# UNITED STATES PATENT AND TRADEMARK OFFICE

10/594,733

Hiroshi Shibaoka

<b>Office Action Summary</b>	<b>Application No.</b> 10/594,733	<b>Applicant(s)</b> SHIBAOKA ET AL.	
	<b>Examiner</b> JENNIFER STEELE	<b>Art Unit</b> 1794

**FIG. 2**

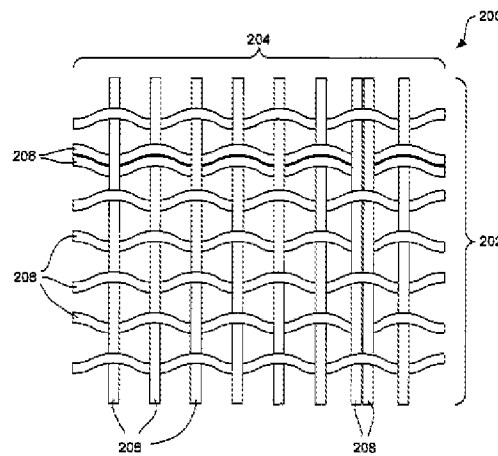
Fukunishi differs from the current application and does not teach a paralleled yarn rip stop yarn which is the equivalent of applicant's B-yarn. Corner teaches blended outer shell fabric for jackets and garments [0001]. Corner teaches woven fabric that are lightweight and employ a rip stop weave [0014]. Corner teaches the rip stop yarns have a construction similar to the body yarns but are provided in pairs that are woven through the fabric as show in Corner's Fig. 2 below. Corner teaches a paralleled secondary, B yarn.

It would have been obvious to one of ordinary skill in the art at the time the invention was made to employ a rip stop woven fabric with a rip stop yarn that is a paralleled yarn motivated to produce a lightweight fabric for outerwear that also has strength provided by the rip stop yarn.
